**CONWAY**
HISTORIC DISTRICT COMMISSION
JUNE

**CONWAY
HISTORIC DISTRICT COMMISSION
MEETING**

1. Norris New Residence and Detached Garage

2. Conway Corporation New Office Building

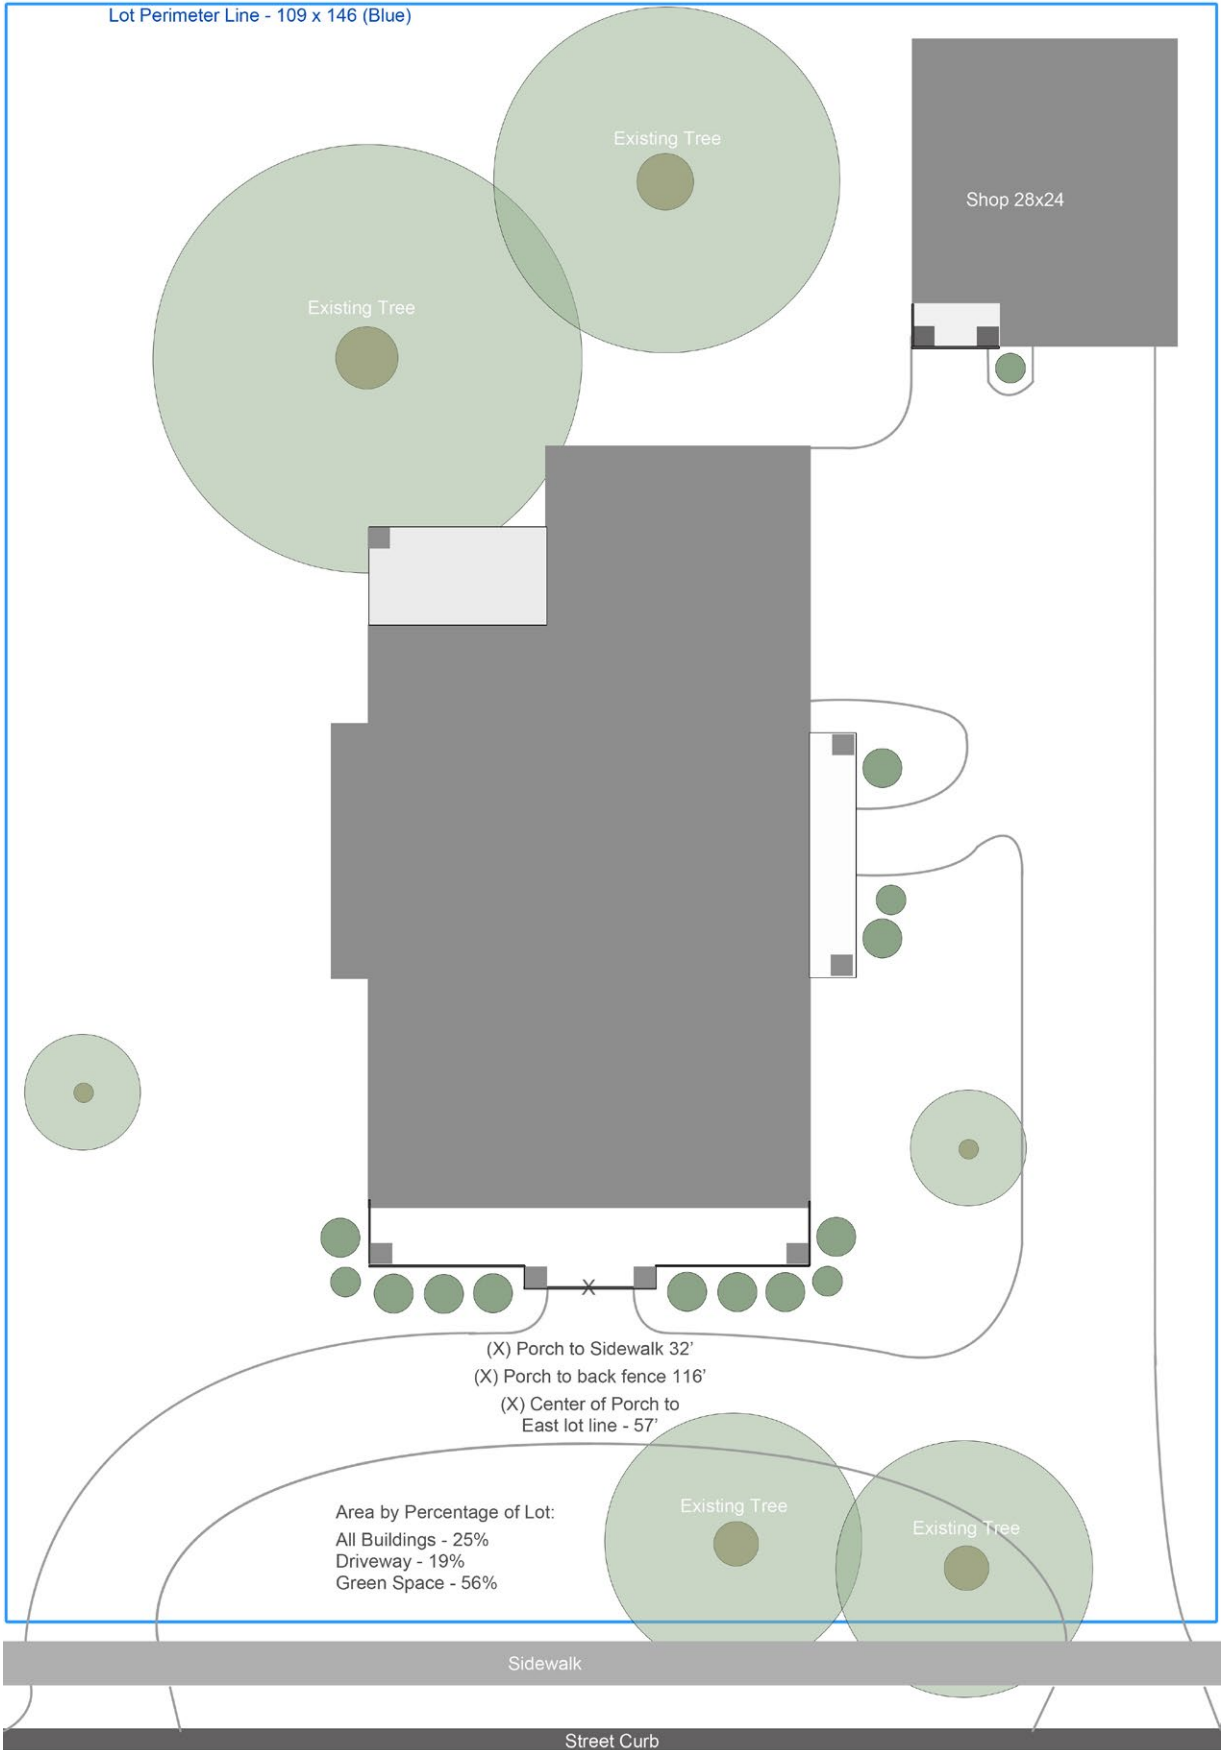
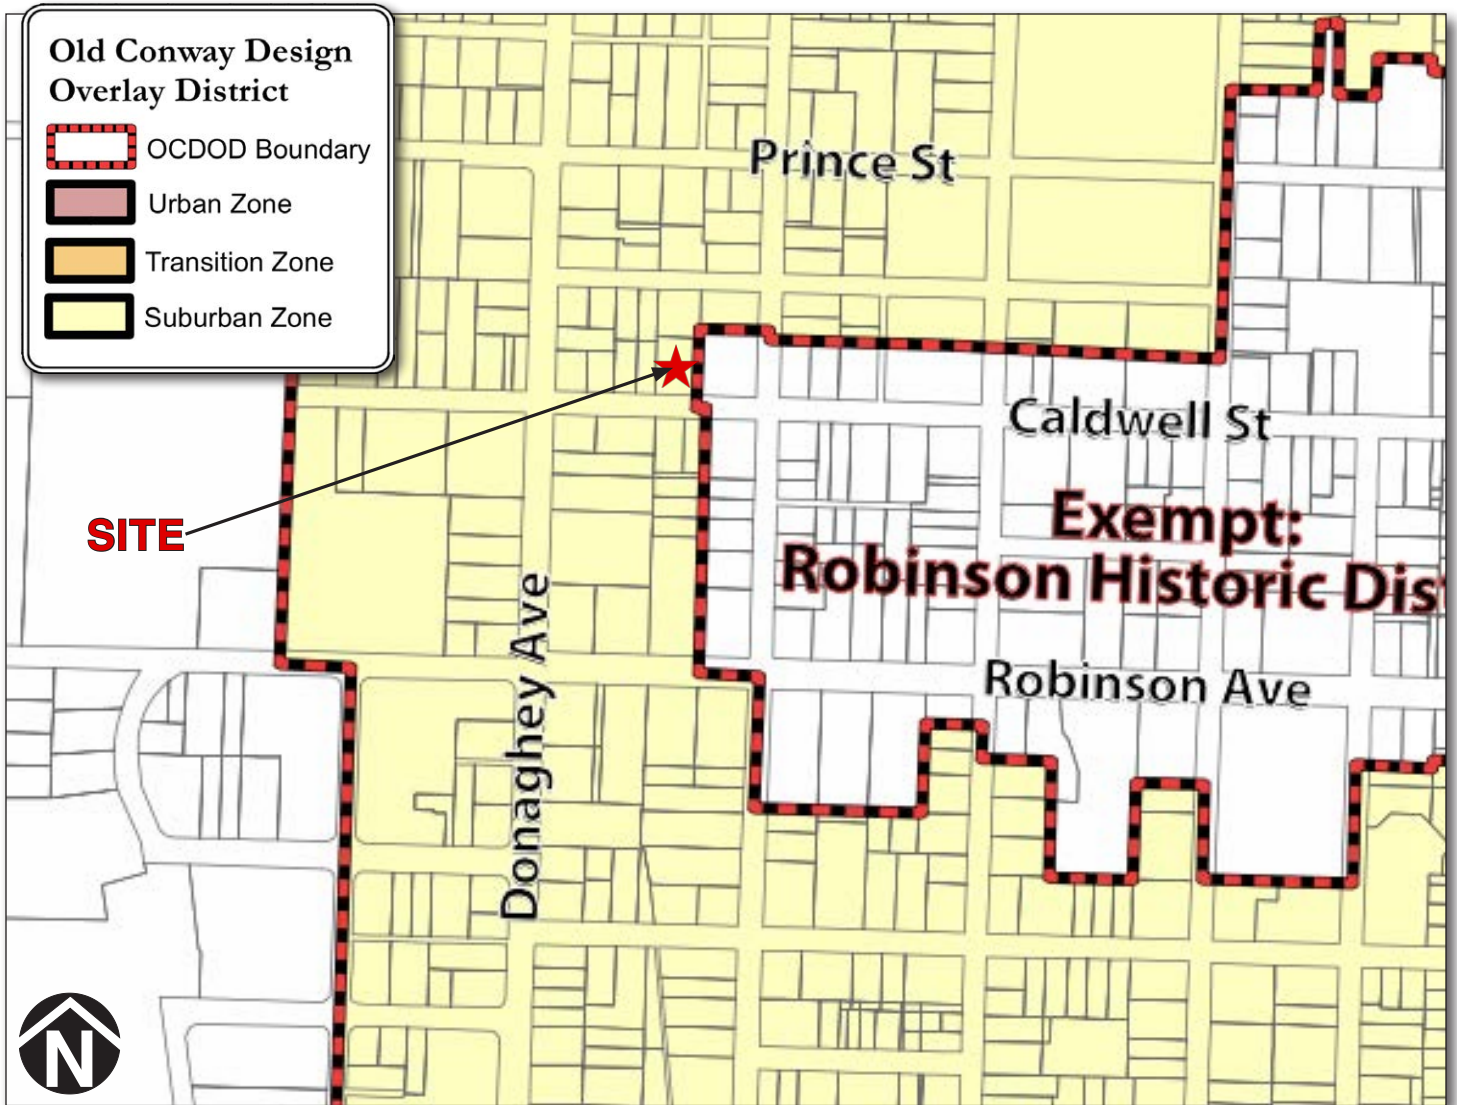
Mechanical Screening. HVAC units should be visually located away from streets or screened by landscaping. Exterior HVAC ductwork should not be visible from the street. No HVAC equipment is shown on the plans. It is assumed that units will be located at the rear or side of the residence and shop. The applicant can provide more details at the meeting.

1. The residence and outbuilding shall be constructed as shown on submitted plans.
2. Roofs shall be asphalt architectural shingle.
3. A semi-circular driveway shall be allowed due to the large size of the lot and traffic driveway access difficulty.
4. Setbacks as proposed on submitted plan for residence and outbuilding shall be allowed.
5. Tree preservation best practices shall be used to preserve existing significant trees.
6. HVAC units shall be placed at the rear or side of the structures and screened appropriately if viewable from the public street.

Exterior Elevations

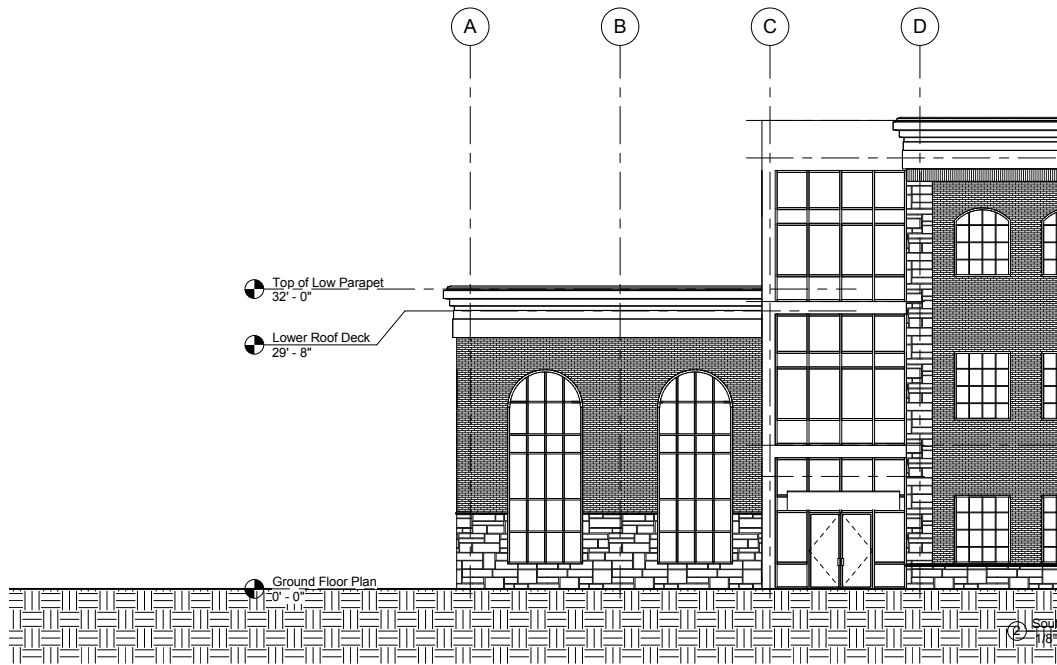
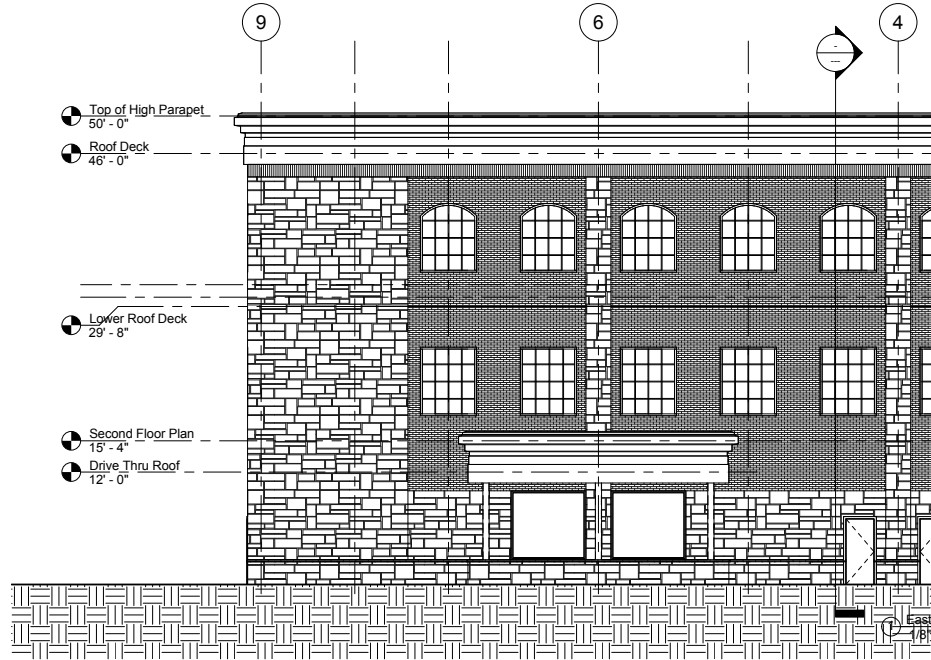
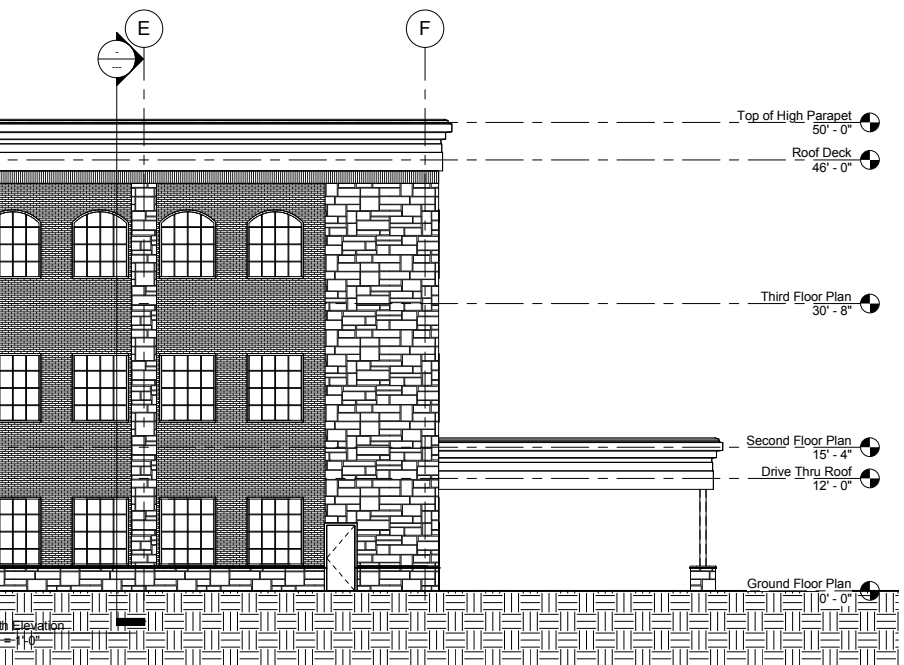
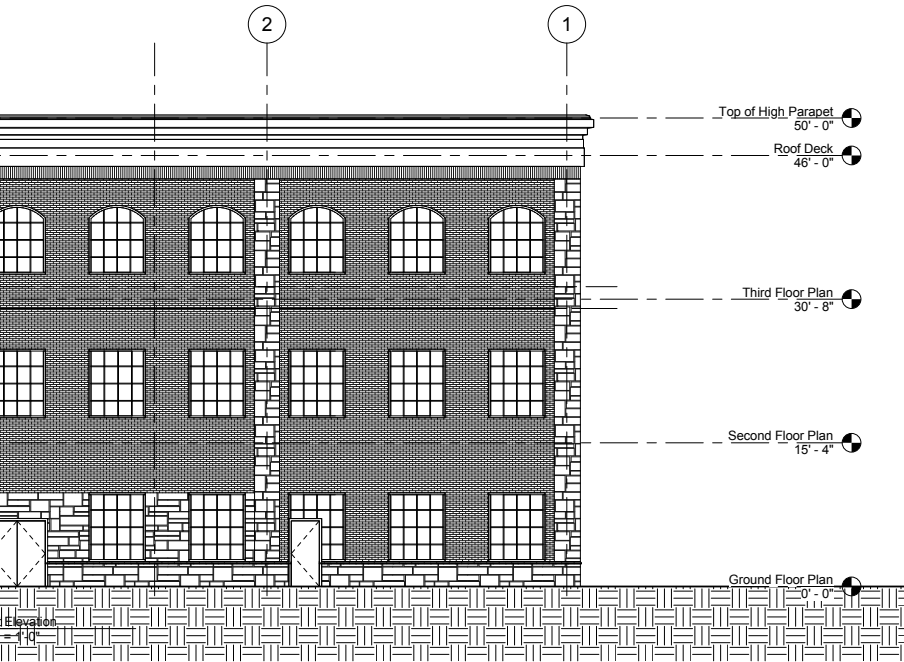
Orientation. The direction in which the front of a building faces. As a corner structure, the building has two "fronts" one on Locust and one on Prairie. These "front" façades present an adequate level of detailing and complexity, however, entry doors on these façades should be provided and better defined.

Entries, Porches, and Porticos. Public entry doors are shown on the south and possibly north elevation. It would seem appropriate to place double doors on the north and west elevation within the glass "tower" area to provide better pedestrian public access. If a double door is provided on the west side, the sidewalk should be increased to provide direct access.

Awnings/Canopies. When new construction uses awnings, traditional awning designs, materials, and placement should be used. Canopies are proposed above the drive through and south entry. If additional doors are provided, appropriate canopies should also be provided.

Architectural Details, Siding, and Bricks. Eaves, brackets, dentils, cornices, molding, columns, trim, etc. The office building is shown with brick, rock, and spandrel glass panels. Although rock veneer is a current construction material trend, it is not a historical material found in the Old Conway area. A masonry base of smooth precast concrete and typical brick might be more appropriate.

1. The office structure and parking areas shall be constructed as shown on submitted plans.
2. Double public access doors are required for access from Locust and Prairie. Sidewalk shall be designed to provide best access to these entries. A canopy cover shall also be provided at these entrances.
3. Low walls as shown on the submitted plans are required to shield the parking lots. The low walls will use matching brick.
4. Sidewalks shall be allowed as submitted in lieu of wide “urban” sidewalks with tree wells.
